City of Rancho Palos Verdes
Rancho Palos Verdes ADA Assessment
Facility Report with Photos

Reporting: 380 of 4367 Rcd Facility ID: # 09 - Lower Point Vicente Park & Point Vicente Interpretive Center (PVIC)

Keynote 161

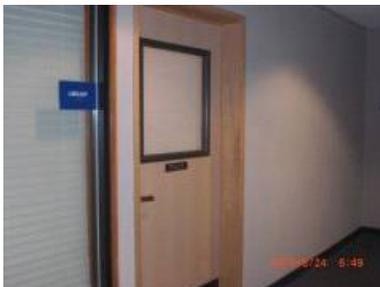
Field Condition	
11.15B_04AG - Vision Lights - Door, gate, or adjacent sidelight, containing one or more vision lights, does not include at least one vision light mounted with the bottom edge of the glazed panel at 43" max.. AFF. (Exception: Vision lights with the lowest part more than 66" AFF.)	1991 ADAAG -
Existing Condition: 47 1/2" high.	2004 ADAAG 404.2.11
	2007 CBC -
	Other -
